***MODIFICATION REQUEST:  
Hurstville Private Hospital  
37 Gloucester Road, Hurstville  
(MP 11\_0042 MOD 2)***

Modification to the internal layout, changes to the façade, increase in height of the lift shaft and expanded plant area on the rooftop

Secretary's Environmental Assessment Report  
Section 75W of the *Environmental Planning and  
Assessment Act 1979*

December 2014

**Figure 2 – Location of lift core and plant area on roof**

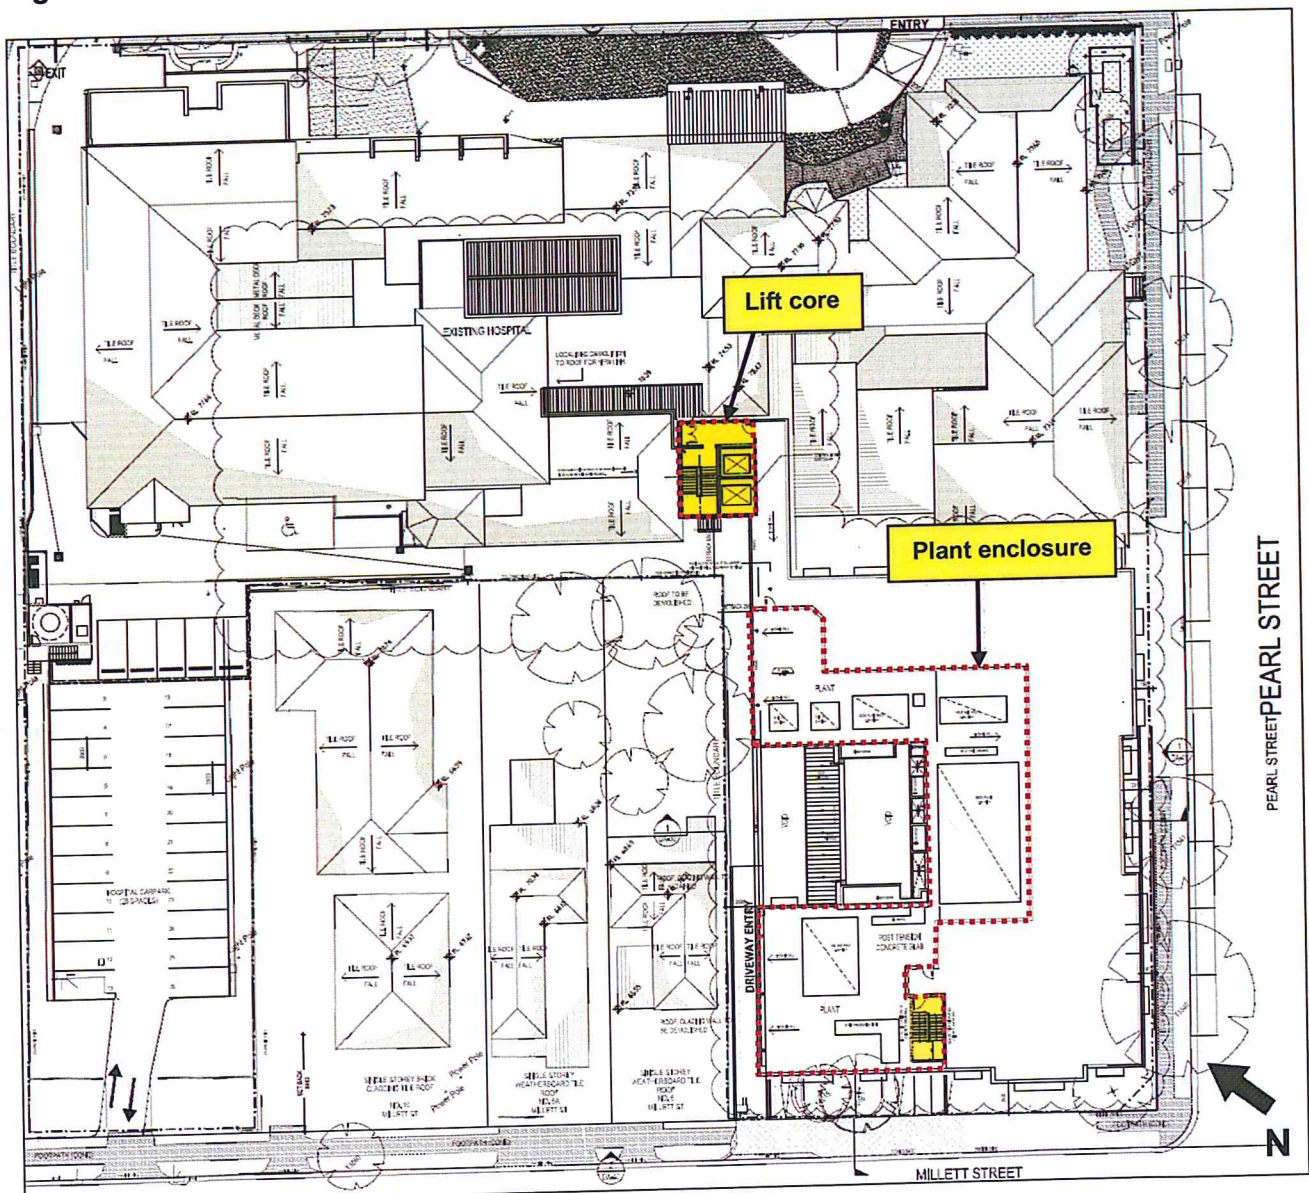
The approved development includes a lift core in the main hospital building which terminates at Level 4 (the top floor). The modification application seeks approval to extend the lift core and stairs to the rooftop to facilitate proper access for the maintenance of the mechanical plant. As a consequence, the parapet height of the lift overrun would increase by 2.52 m above its approved height. The location of the lift core and proposed plant rooftop enclosure is shown in **Figure 2** and a comparison between the approved development and the proposed modification is illustrated in **Figures 3 and 4**.

The proposed modification also seeks to expand the footprint of the mechanical plant on the rooftop (see **Figure 2**) which would add to the height and bulk of the main hospital building when viewed from the west. The previous modification application (MOD 1) approved the removal of an entire floor from the main hospital building, resulting in a corresponding reduction in height by approximately 2 m compared to the originally approved development application. The additional plant area proposed in this modification application would be contained within the originally approved building envelope, and there would be no additional visual or amenity impacts to adjoining properties beyond that which has already been assessed as reasonable in the originally approved application (refer to **Figure 5**). The Department therefore concludes that the additional bulk and height associated with the expanded footprint of the plant area to be acceptable.

Figure 4 – View from the rear of No. 6 Millet Street (as proposed)

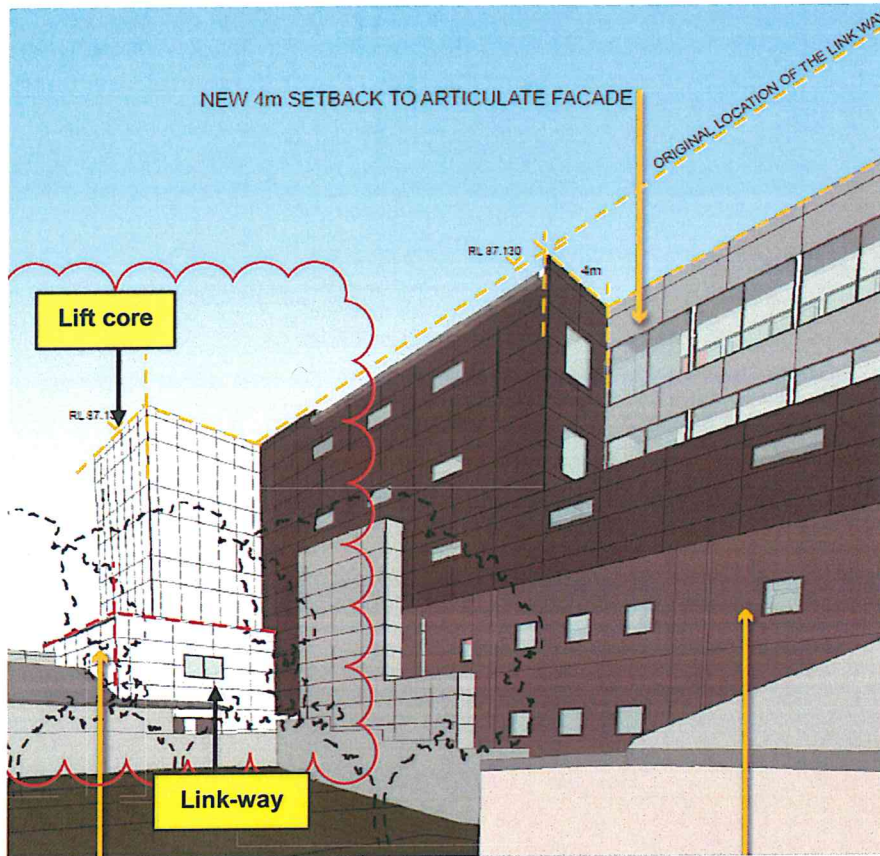
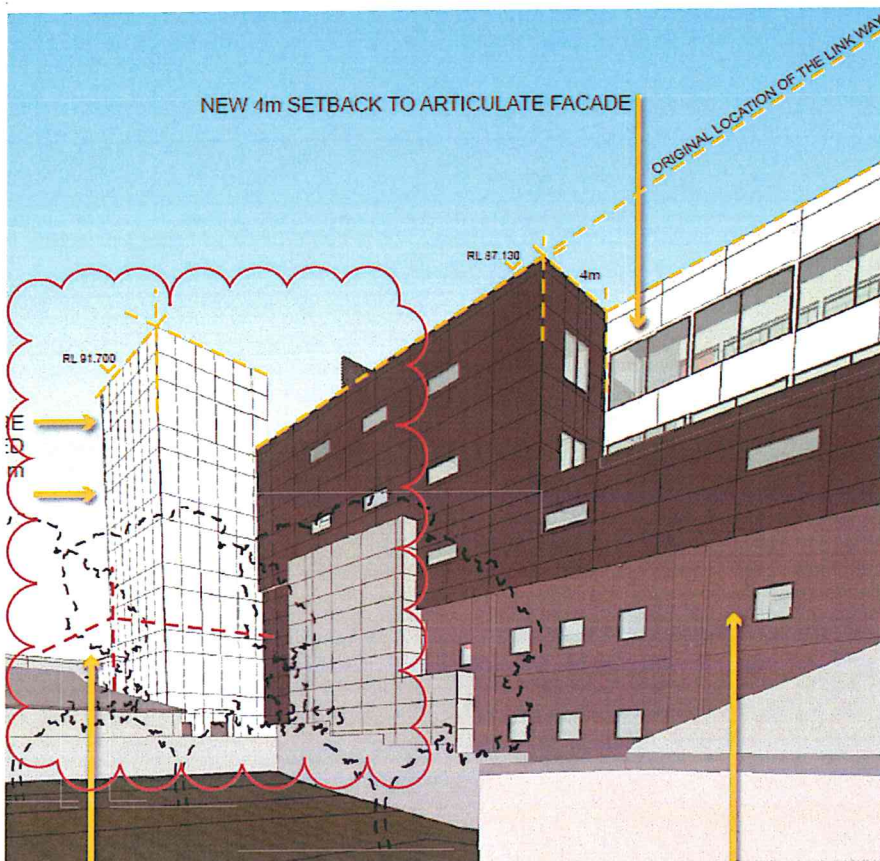
The Department notes a key assessment issue relates to the increased height and any resultant adverse visual impact from the public domain. The lift core is centrally located on the northern side of the main hospital building which is 40 m to 50 m to the nearest street frontages. The proposed additional height of the lift overrun would therefore be relatively unobtrusive when viewed from the surrounding streets due to the generous separation distance. The Department concludes that the proposed additional height of the lift overrun would not give rise to any significant visual impact when viewed from the public domain.

The additional height associated with the lift core also has the potential to adversely impact on the amenity currently enjoyed by the adjoining low scale residential properties directly to the south-west, fronting onto Millet Street. The proposed additional height would be readily visible above the parapet of the main building from these properties. However, the additional height would be offset by the removal of the link-way at the base of the lift core (as a consequence of the link corridor being relocated to the Gloucester Road side of the core), which would introduce a more slender building form (see **Figure 4**). The additional height associated with the lift overrun would also introduce some articulation to the roof line and assist in breaking up the mass of the building when viewed from the rear of the adjacent residential properties. Shadow diagrams submitted with the modification application demonstrate that there will be negligible additional shadow impacts on the rear of residential properties in Millett Street.

The Department is satisfied that reasonable access to sunlight and ventilation would be maintained to adjoining residential properties, and in the absence of any amenity impacts, concludes that the visual impact associated with the additional height of the lift parapet is reasonable.
